DAVIS-BESSE IMPROVED TECHNICAL SPECIFICATIONS CONVERSION

ITS SECTION 3.7 PLANT SYSTEMS

ITS 3.7.1, MAIN STEAM SAFETY VALVES (MSSVs)

**Current Technical Specification (CTS) Markup
and Discussion of Changes (DOCs)**

Equation Figure 3.7.1-1 (page 1 of 1) High Flux
Reduced Power and Nuclear Overpower Trip Setpoint versus OPERABLE Main Steam Safety Valves 1 2

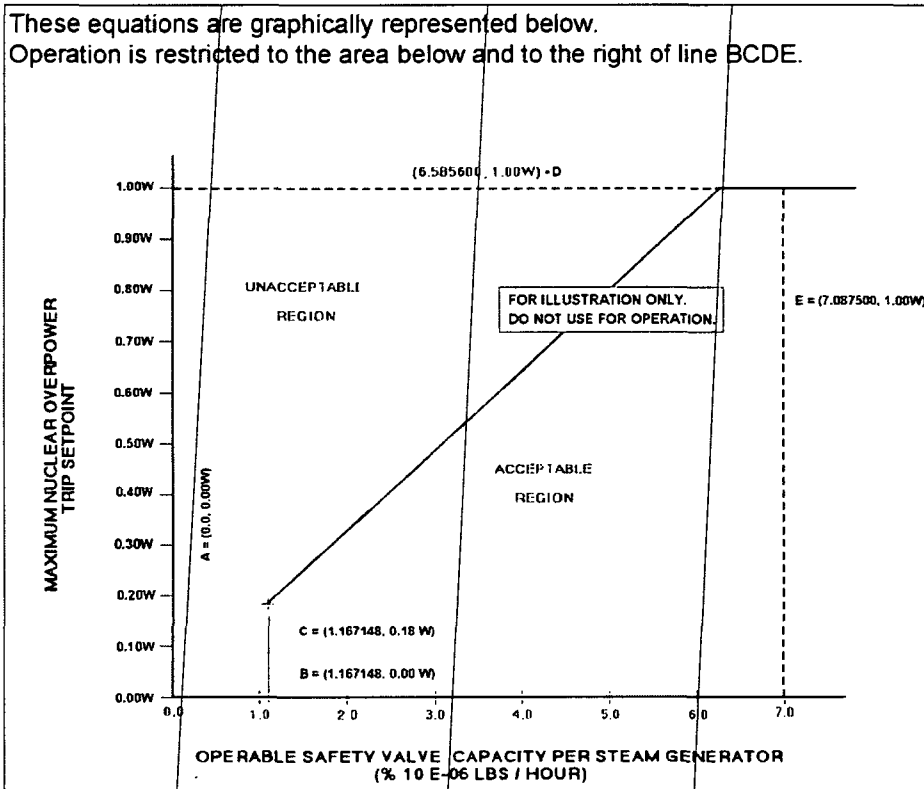
1. All of the installed MSSVs for Davis-Besse must be OPERABLE. All MSSVs listed in Table 3.7.1-1 (nine total MSSVs per steam generator) are required OPERABLE, and Figure 3.7.1-1 is only used when one or more of the MSSVs are inoperable. Therefore, ISTS LCO 3.7.1 has been changed to delete the reference to Figure 3.7.1-1. Since all installed MSSVs are required, the term "required" in ISTS 3.7.1 Condition A and ISTS SR 3.7.1.1 have been deleted. Furthermore, the equation presented in ISTS Figure 3.7.1-1 is sufficient to determine the necessary power reduction and High Flux trip setpoint reduction. Therefore, the graphical representation of the equation has been deleted and the Figure has been renamed as an Equation.

4. The brackets have been removed and the proper plant specific information/value has been provided.
5. Editorial correction.
6. The Davis-Besse overpressure protection analysis requires one of the OPERABLE MSSVs be set at 1050 psig \pm 3%. Therefore, this requirement has been included in Condition B, similar to the minimum number of OPERABLE MSSVs requirement also included in Condition B.

Figure 3.7.16-1 (page 1 of 1)
Burnup versus Enrichment Curve for
Spent Fuel Storage Racks

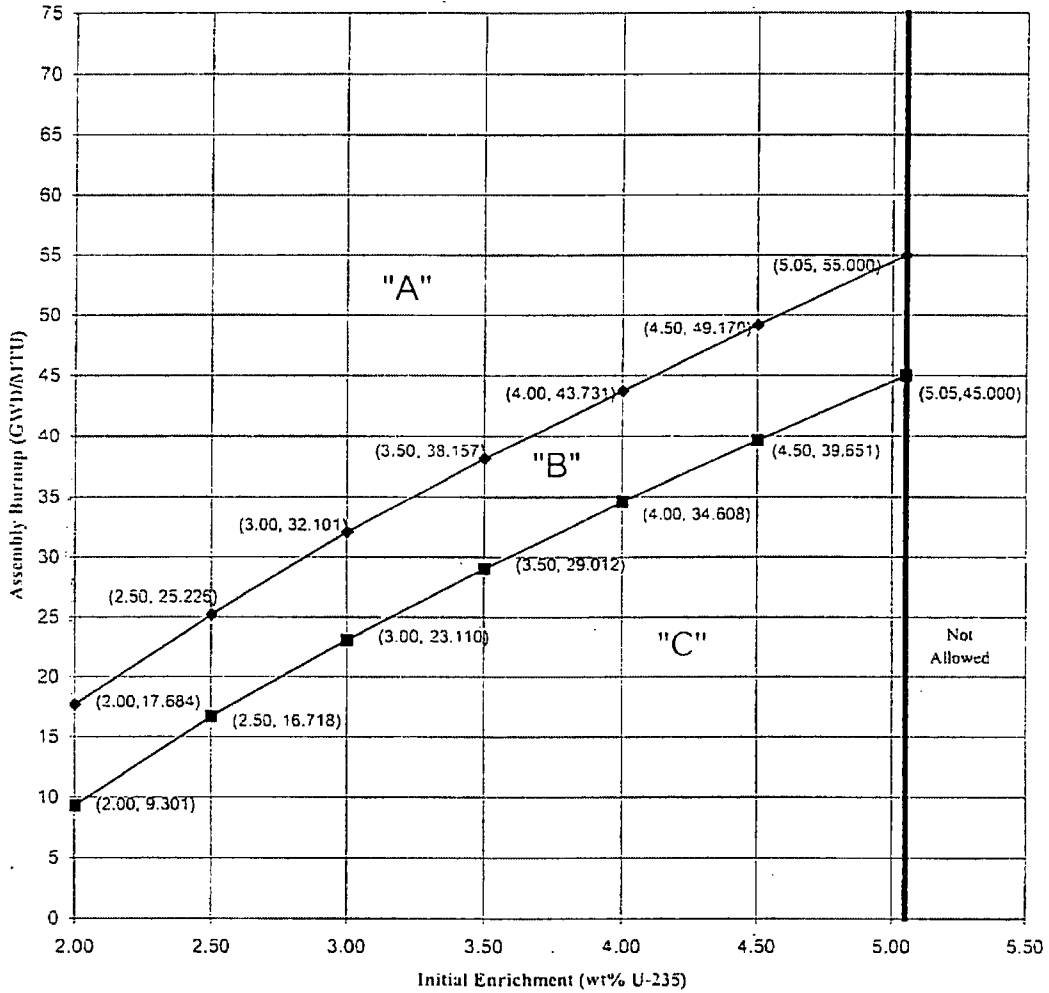
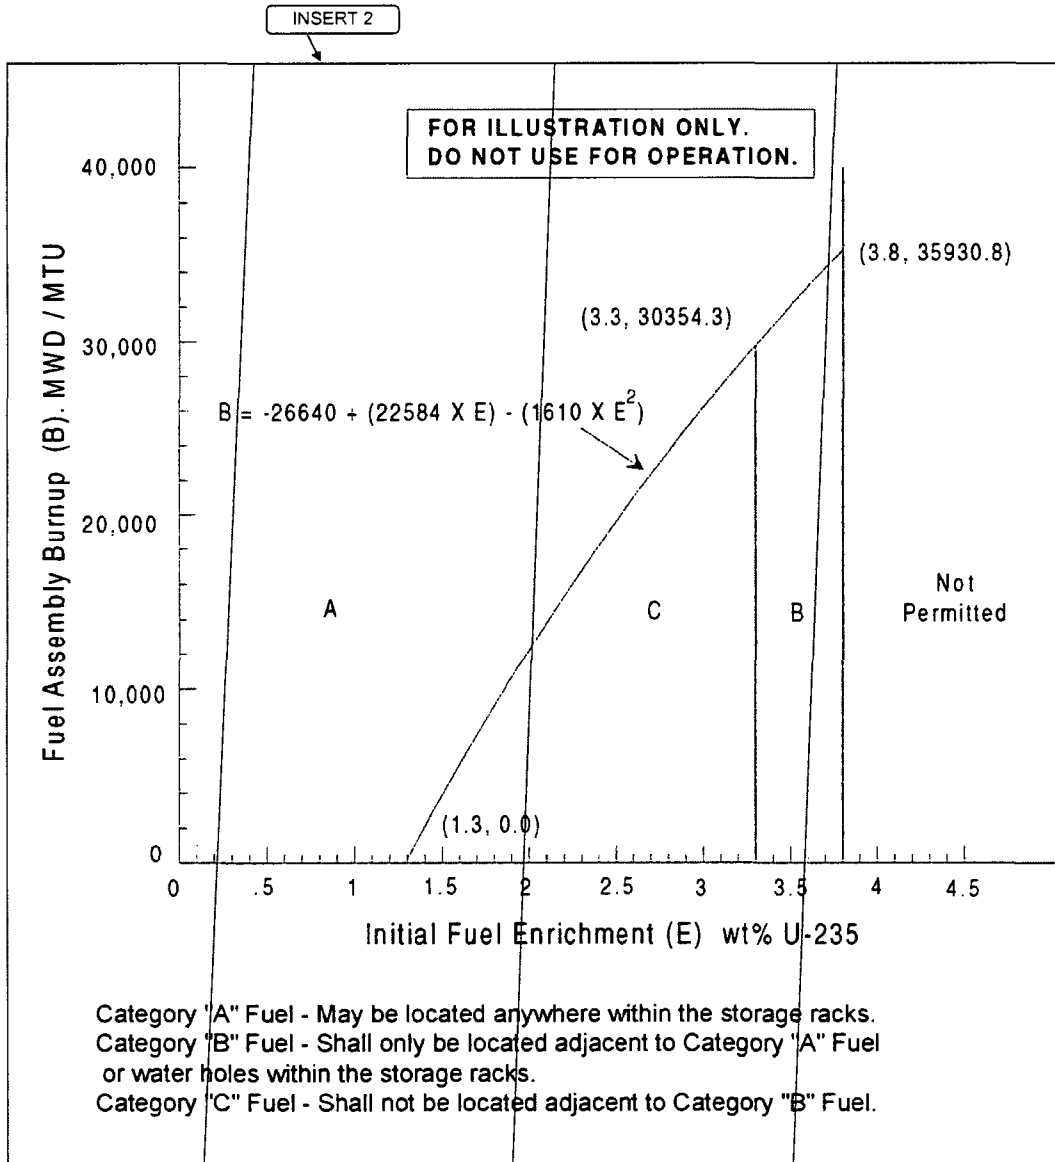
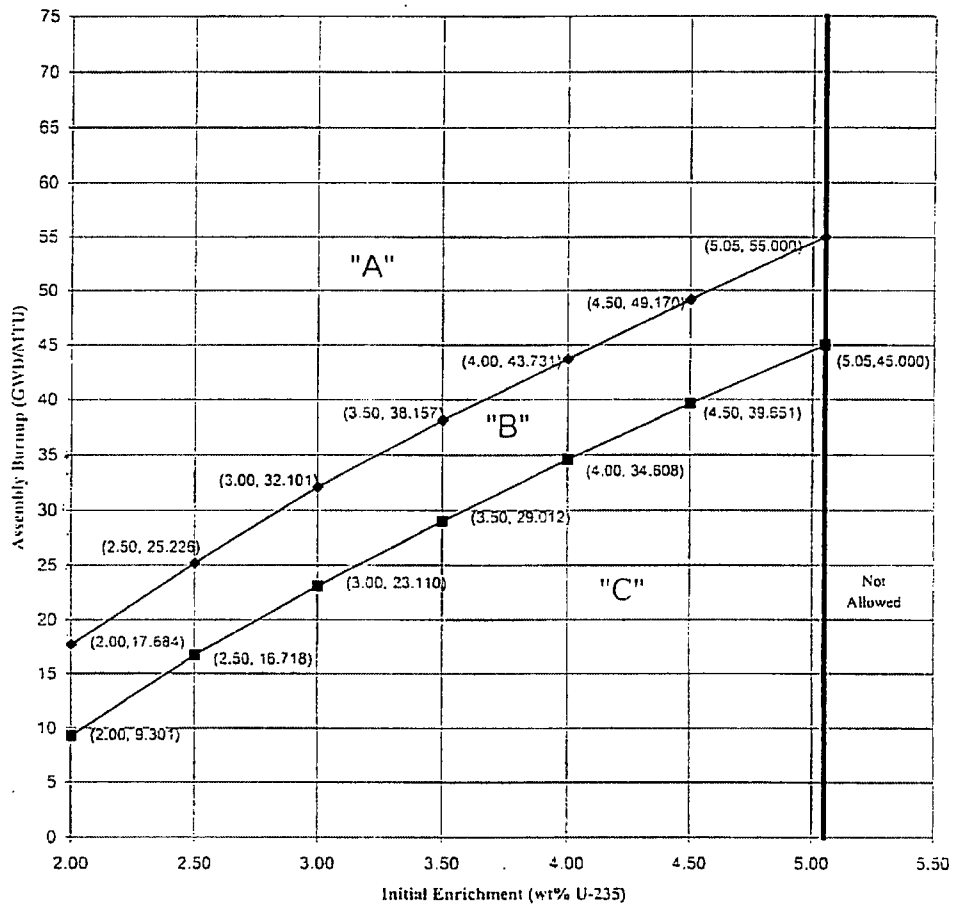
- A03 CTS 3.9.13 Action, in part, states that with the requirements of the Specification not satisfied, to move the non-complying fuel assemblies to allowable locations in accordance with Figure 3.9-1. ITS 3.7.16 Required Action A.1 requires action to be immediately initiated to move the noncomplying fuel assembly to an allowable location. This changes the CTS by explicitly specifying that the compensatory action to move non-complying fuel assemblies to allowable locations requires an immediate response.

Figure 3.7.18-1 (page 1 of 1)
Maximum Allowable Steam Generator Level

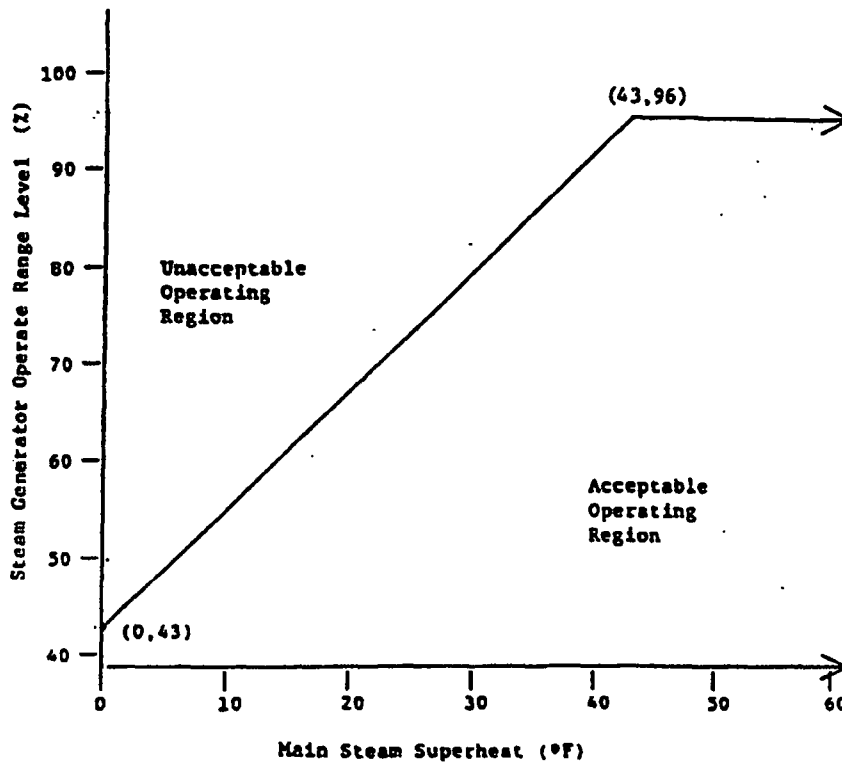
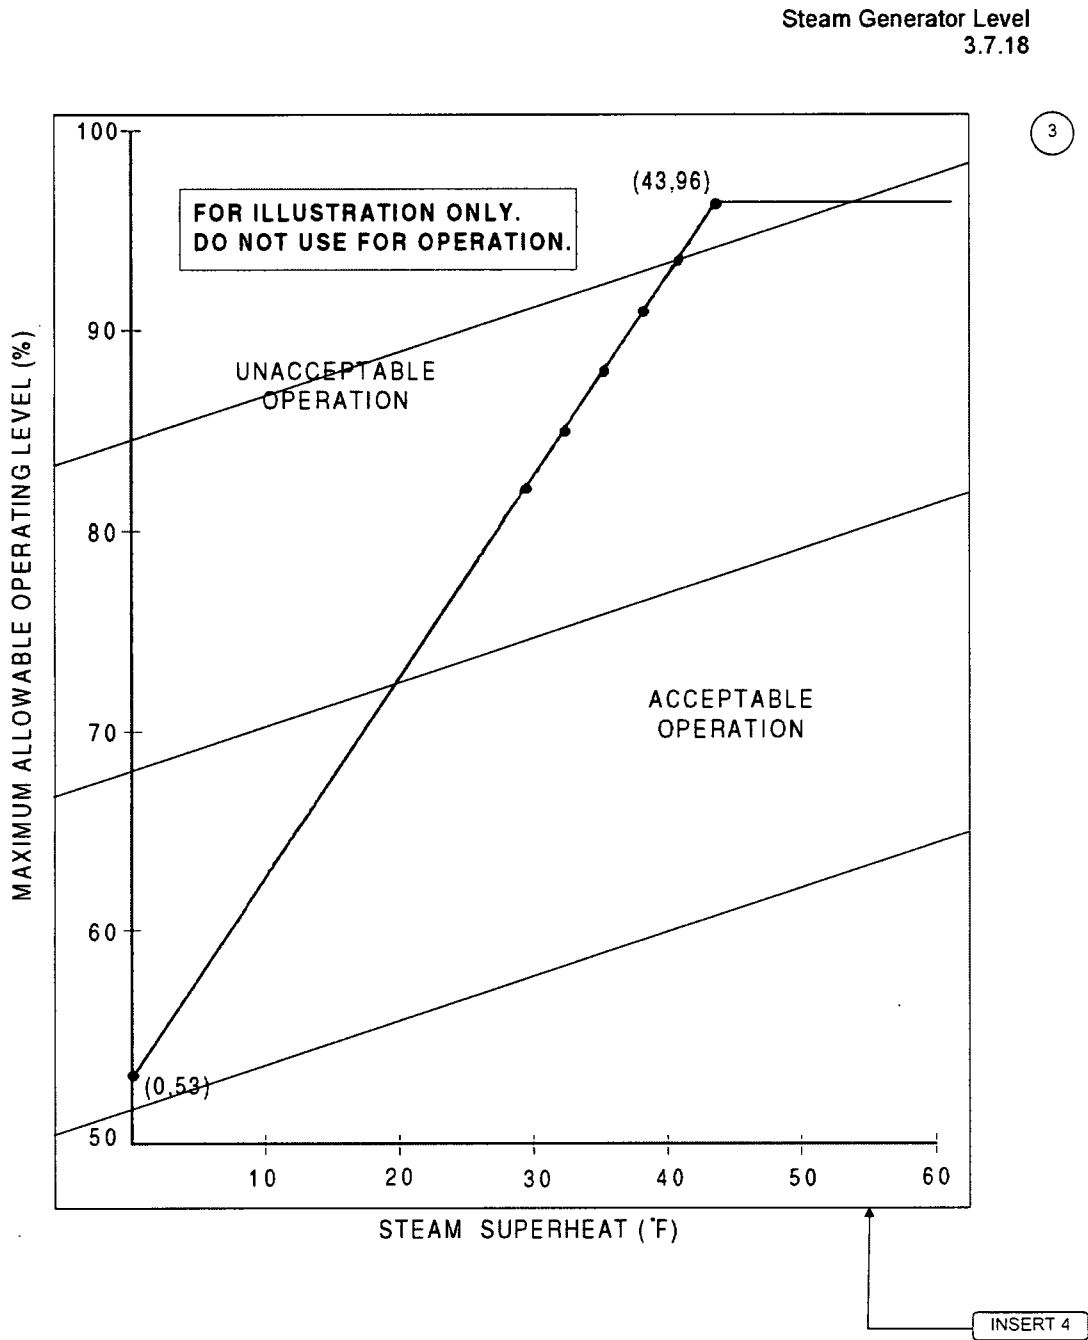
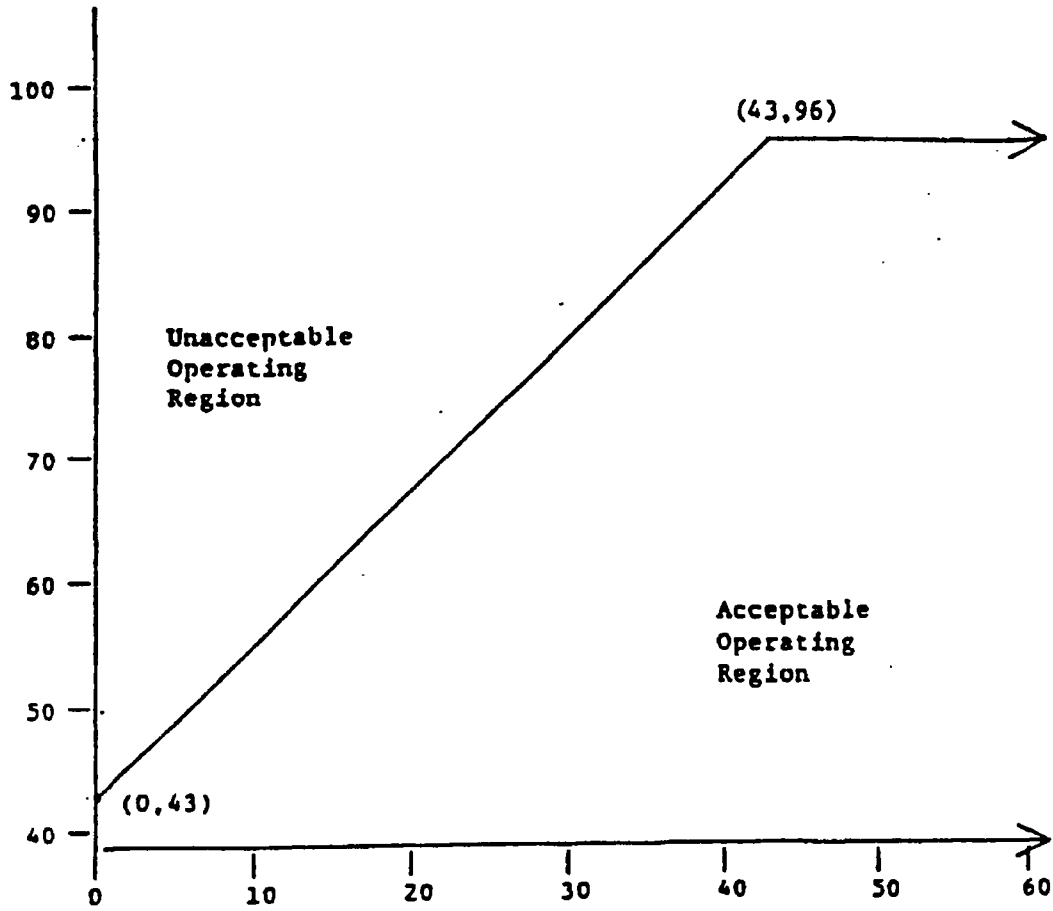
. Figure 3.7.18-1 was reviewed following reanalysis of the MSLB, which assumed approximately 56,000 lbm, and was considered to remain bounding. It has been determined that the plant response when operating at the limit of the Figure is consistent with the MSLB analysis.
